August 13, 2013

Re: Alabama Power Company's Comments on Draft Environmental Impact Statement for Martin Dam Hydroelectric Project – FERC Project No. 349-173

Figure 1.

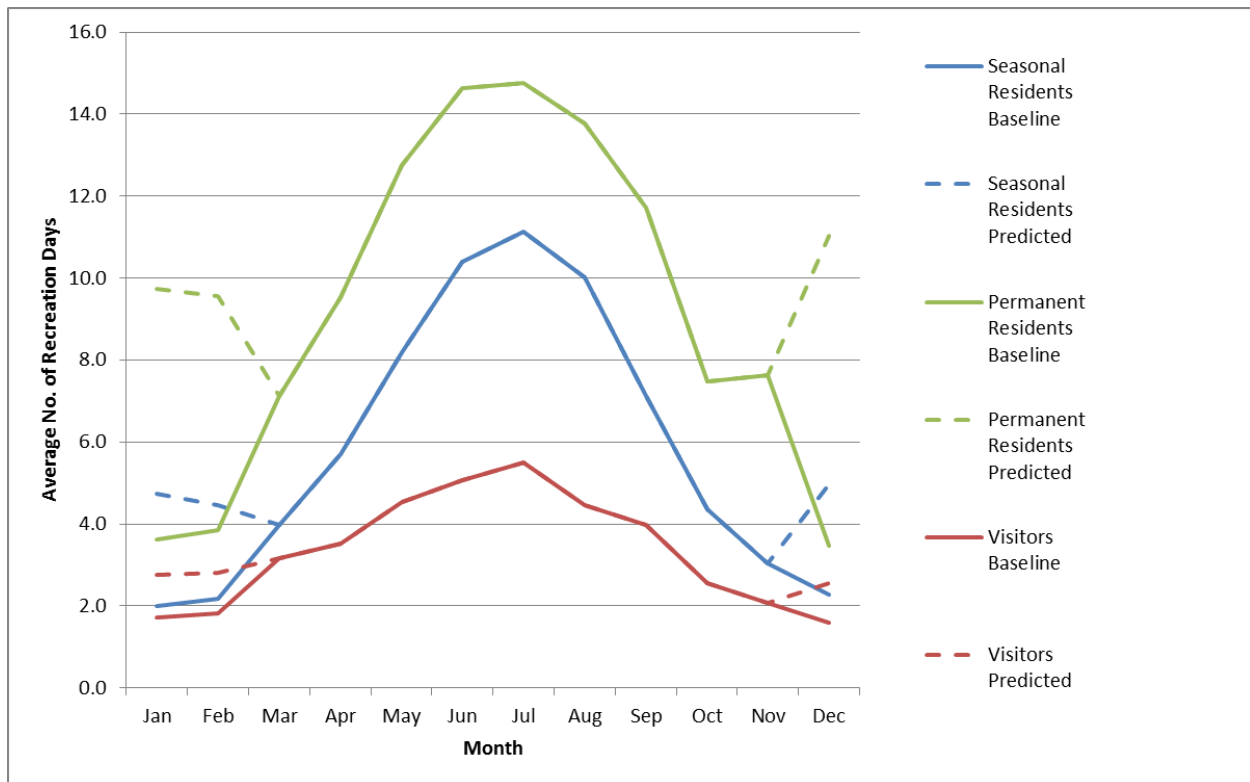
On pages 108 and 109, staff states that the proposed increase in winter pool will primarily benefit shoreline owners and their private docks. While these owners may receive a direct benefit from the winter pool increase, the local economy will also benefit from the increase in recreational use, as evidenced by study results. For example, Alabama Power re-analyzed the data from Study 12g so that “all shoreline landowners” were separated into unique categories, resulting in a predicted increase of 8 percent for seasonal residents due to an increase in the winter pool of 3 feet (in addition to the 6 percent increase in trips for permanent residents already reported). Viewing the predicted increases in average recreation use by month demonstrates that projected increased use is directly correlated to the proposed 3-foot increase in winter pool. (Figure 1).

Figure 2.

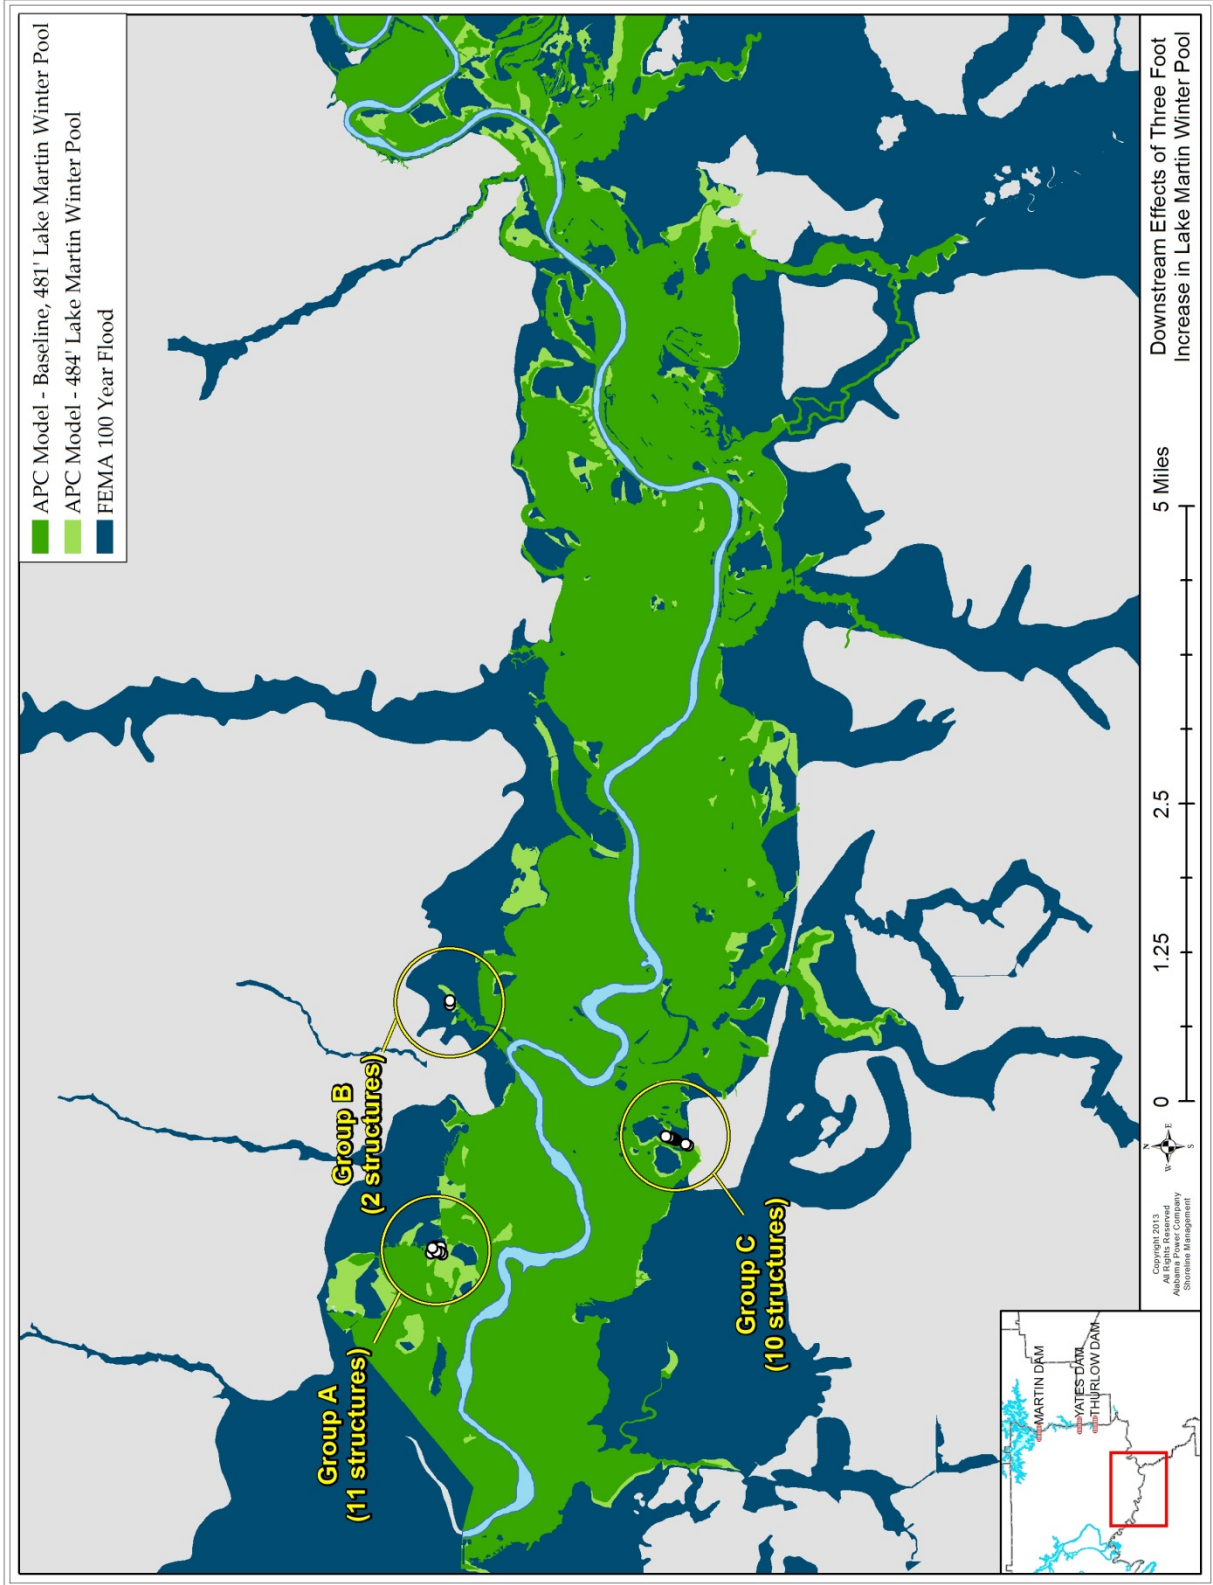
As the following maps and table demonstrate, Alabama Power is not changing the risk already assumed by the structures downstream that are already well within the current FEMA “100 yr” floodplain and already subject to the floodplain development requirements for Elmore, Montgomery and Tallapoosa counties.

Figure 3.

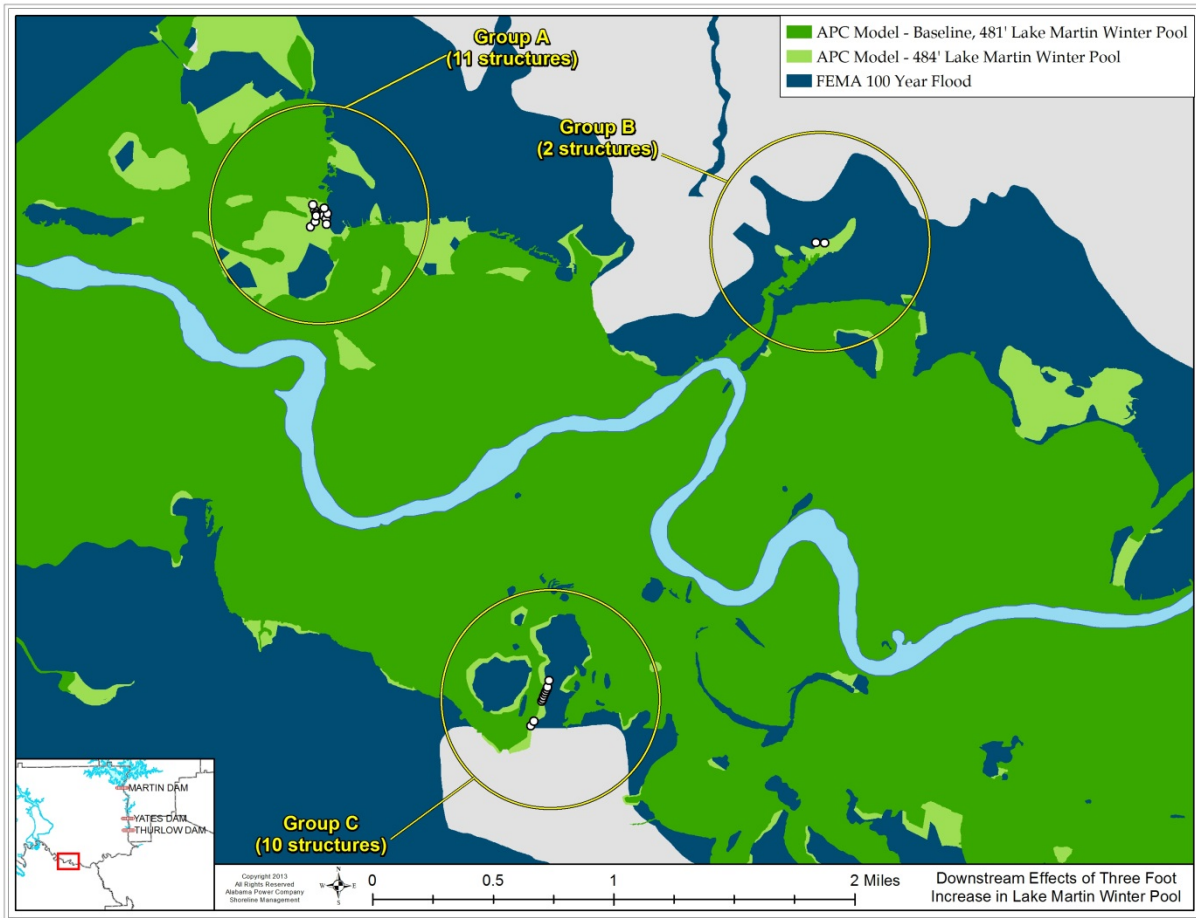
The table below shows the FEMA flood range for the three areas shown on the maps where potential additional flooding may occur, as well as Alabama Power’s modeled flood elevation range for those same areas. In each instance, Alabama Power’s modeled flood elevation range is well below the FEMA flood elevation range.

Figure 4.

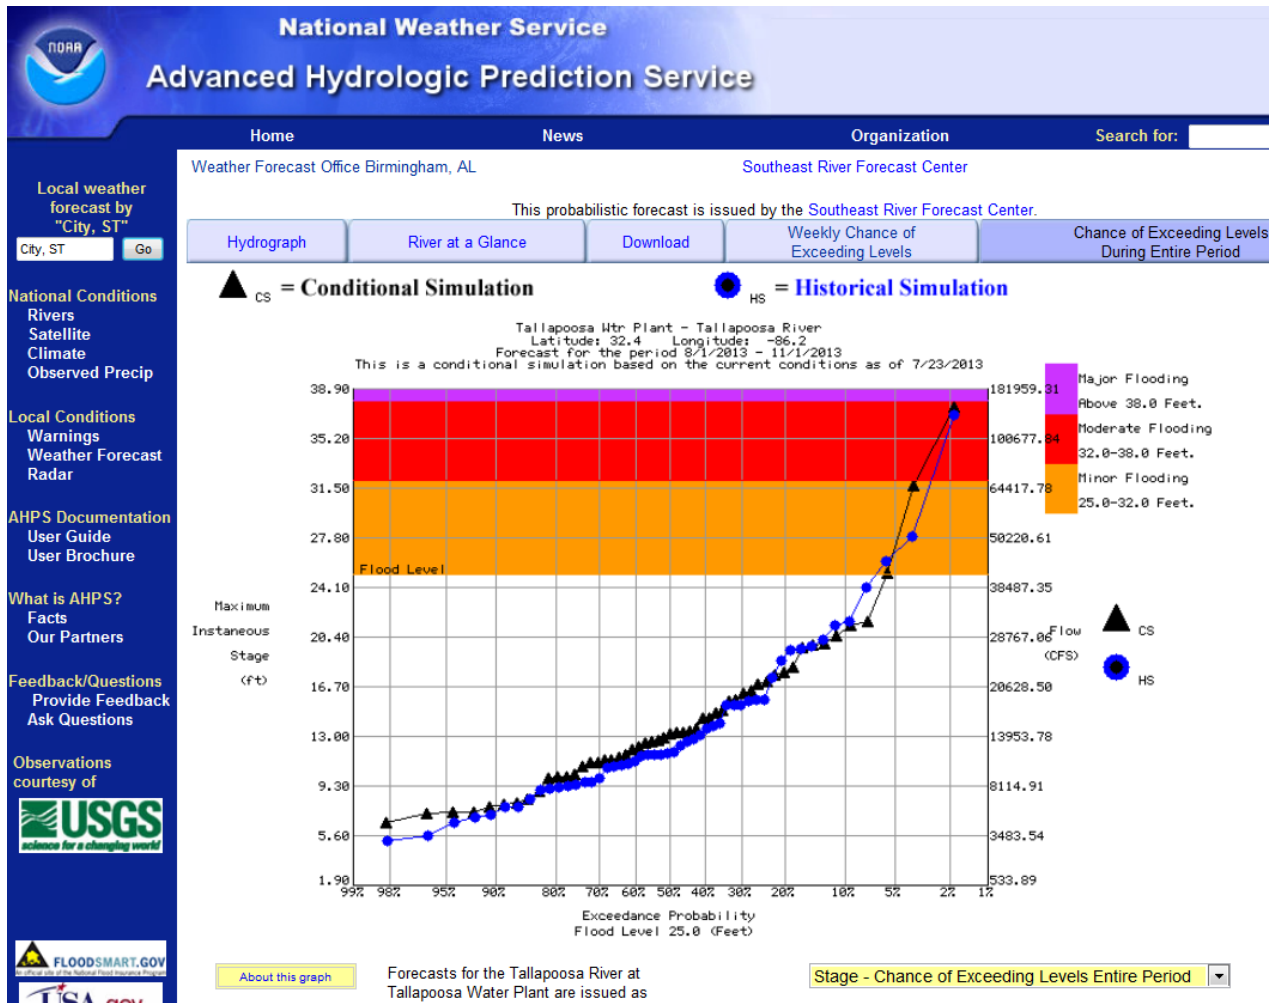
Staff indicated concern for public safety with some roads listed as flooding on the Southeast River Forecast Center's ("SERFC") flood impacts page for the Montgomery Water Works. As much of this area is in a floodplain, minor flooding impacts, including flooding to some roads, start appearing as low as a gage height of 25 ft (154 ft NGVD). Then moderate flooding occurs between gage height 32 and 38 (161 to 168 ft NGVD), with major flooding above a gage height of 38 feet. As was shown in Study 12a, the proposed 3 foot higher winter pool for Martin only results in a 1.5 foot higher peak at Montgomery Water Works with the conditions of the Alabama Power modeled flood. Also Figure 2.8.7.1-6 of Study 12a shows that the 1.5 foot rise still keeps the flood peak within the moderate flooding zone. Much higher intervening flows in the unregulated reach would be needed to push the peak at Montgomery Water Works above the moderate flood zone. In addition, as shown in Figure 4. below, SERFC has determined that the 50 year exceedance level is near the 38 ft stage separating the moderate and major flood zones. Since the roads and structures listed on the SERFC webpage for the Tallapoosa Water Plant (Montgomery Water Works) are well within the 100 year FEMA flood zone, and apparently below the 50 year flood level, they qualify for the NFIP and are already subject to fairly frequent flooding. The risk, as defined by FEMA, and the owners' ability to purchase insurance would not change. FEMA has employed this simple method to mitigate risk because of the almost infinite scenarios that can generate flooding at a particular location within the floodplain. It would be impossible to test every possible scenario; therefore, Alabama Power chose a situation that would show the maximum difference between the baseline and the proposed change to winter pool.

Figure 5.

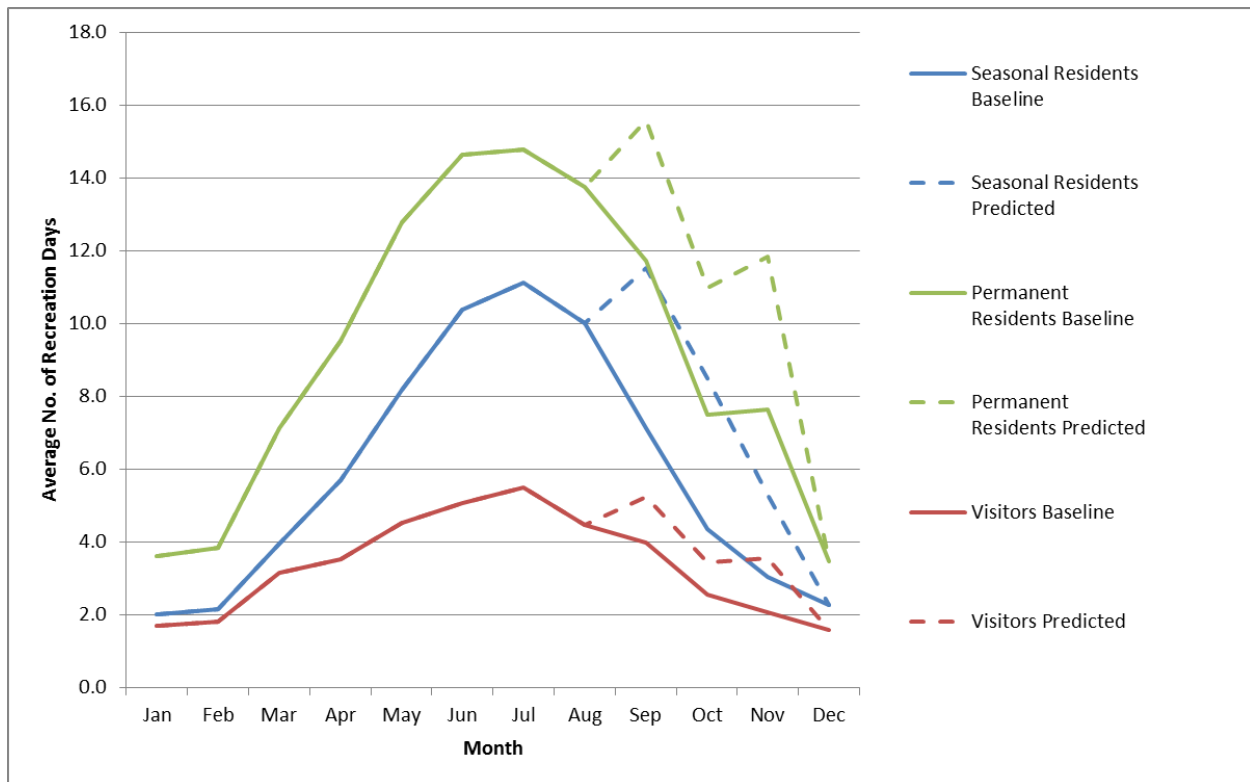
On pages 108 and 109, staff states that the proposed conditional fall extension will primarily benefit shoreline owners and their private docks. While these owners may receive a direct benefit from the conditional fall extension, the local economy will also benefit from the increase in recreational use, as evidenced by study results. For example, Alabama Power re-analyzed the data from Study 12g so that "shoreline landowners" were separated into unique categories, resulting in a predicted increase of 14 percent for seasonal residents when the fall extension is in place (in addition to the 5 percent increase in trips for permanent residents already reported). A review of the monthly predicted increases in recreation use confirms that such use is directly correlated with water levels (Figure 5).

Figure 6.

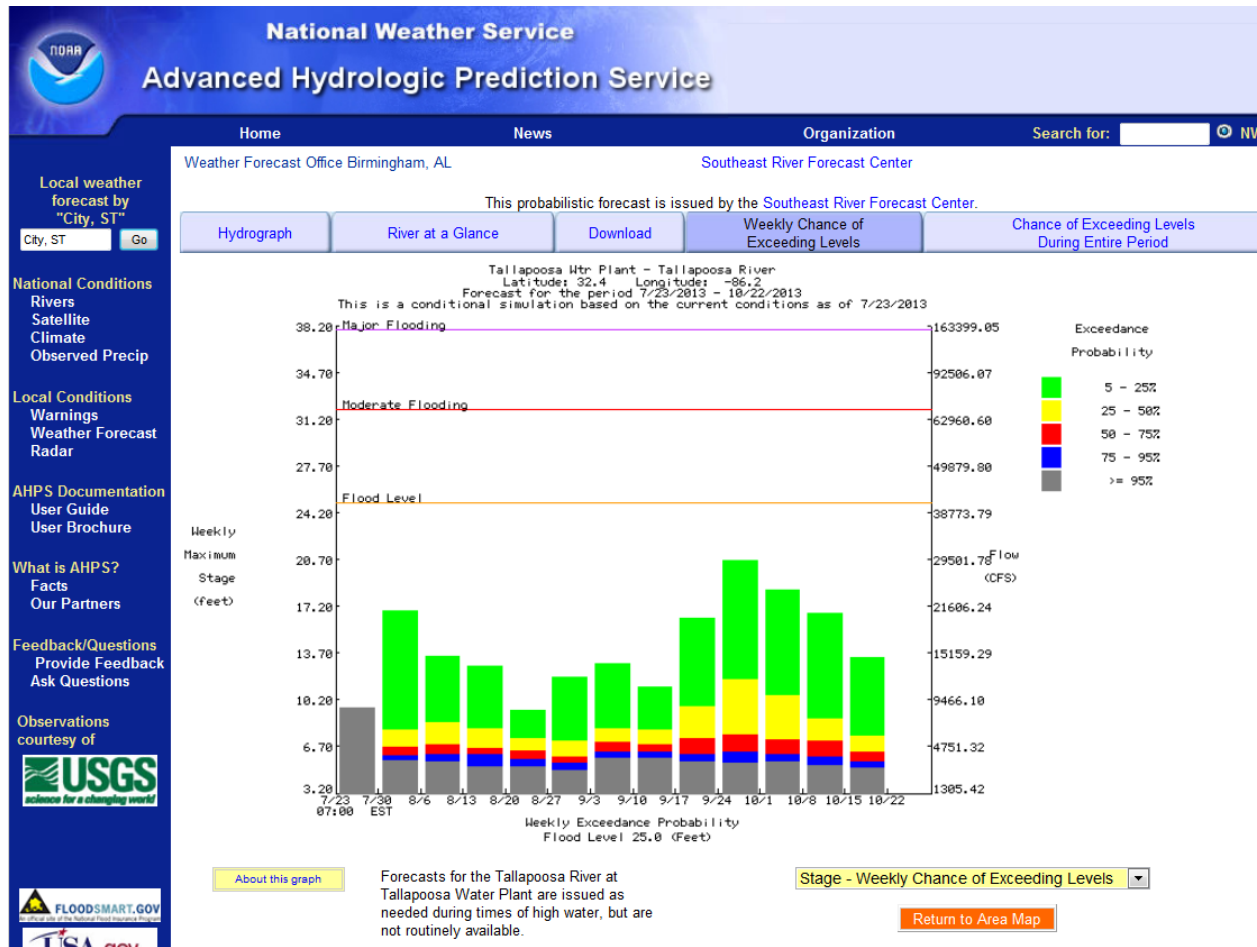
Another way to look at the potential for flooding during the conditional fall extension would be to look at the SERFC page for the Tallapoosa Water Plant, which is also known as the Montgomery Water Works, and is the most downstream point in the geographic scope related to flooding associated with changes at Martin. There is a page for the weekly chance of exceeding levels which is shown in Figure 6. below. Currently, for the September through October 15th timeframe, the chart shows that the chance of exceeding the initial flood level of 25 feet is less than 5 percent. This is based on 50 years of precipitation data and current soil moisture conditions that take into account the very wet summer that central Alabama has experienced in 2013.
